5. Pillar Garnish

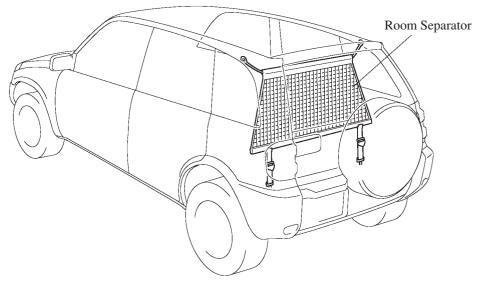
- The shapes of the pillar garnishes have been changed on the models that support the curtain shield airbags.
- Hooks for attaching a room separator only in the rear section have been provided on the models for Europe equipped with curtain shield airbags. (They are available as a set option on the models with rear three-point seat belts.)
